Mondol Fabrics Ltd

Nayapara, kasimpur, Gazipur
(23.990028N, 90.317336E0)

8th March 2014

Observations

Column Stresses in Toilet Area – North of Building

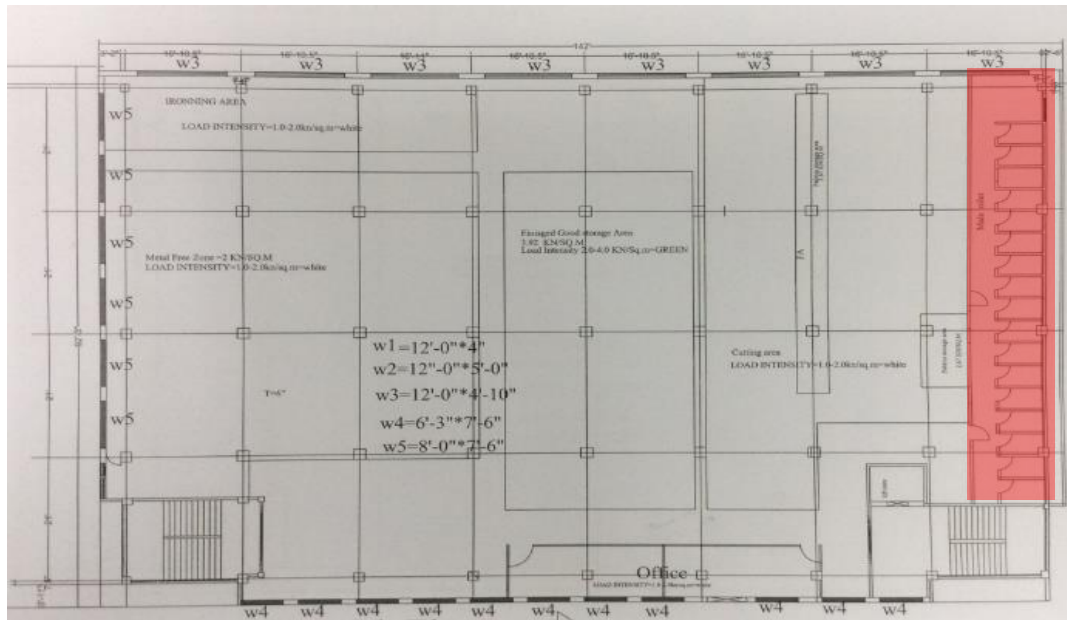
Cursory calculations indicate that column size appears to be smaller than required by code for the applied live & dead (including floor buildup, brick walls, roof slab over toilets and 2 external walls) live load, assuming typical concrete strength

Toilet Area: Columns supporting weight of walls, floor build up, roof slab & 2 façade walls each level.

Building Engineer to perform detailed calculations and concrete tests to prove column size and if required:

- Reduce loads further by removal of heavy walls and floor build-up
- Carry out strengthening works

Water Damage and Vegetation Growth

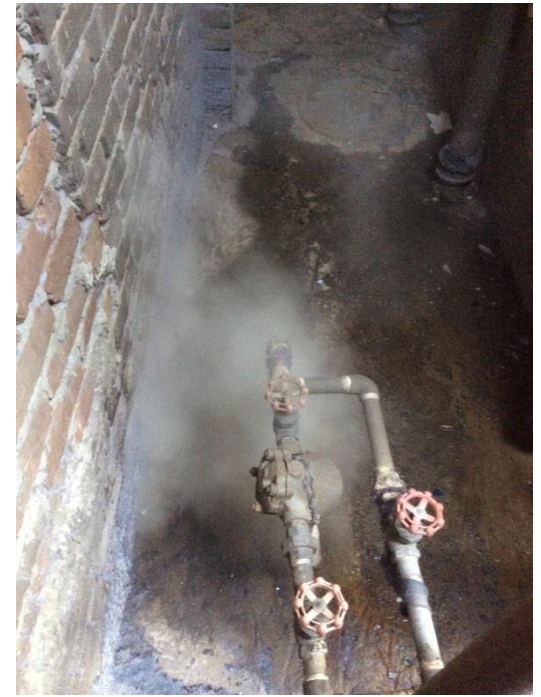
Water damage observed throughout. Building should be generally assessed for sources of leaking water

Leaking water Pipes in toilet areas causing corrosion to structure

Steam rejection causing constant wetting .

Unmanaged leaking water drainage from steam pipes causing corrosion to façade and structure.

Light weight Steel Roof Structures

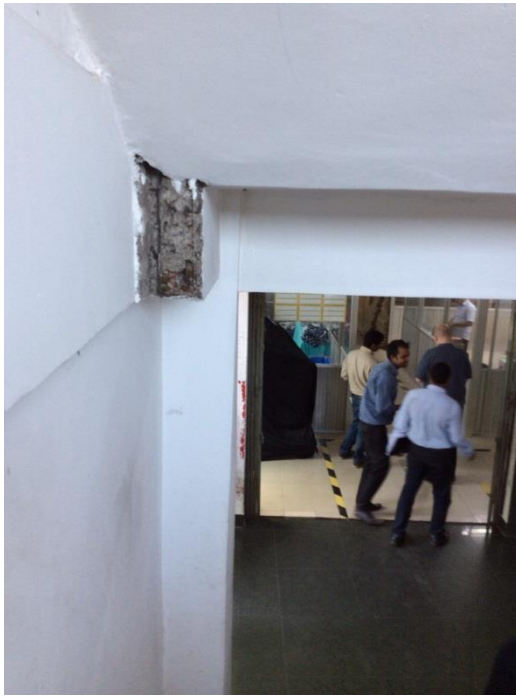
Non-engineered steel roof structure between building 3 and 1 is unlikely to be able to withstand strong wind events.

Corrugated roof sheeting to bridge corroded and in need of repair
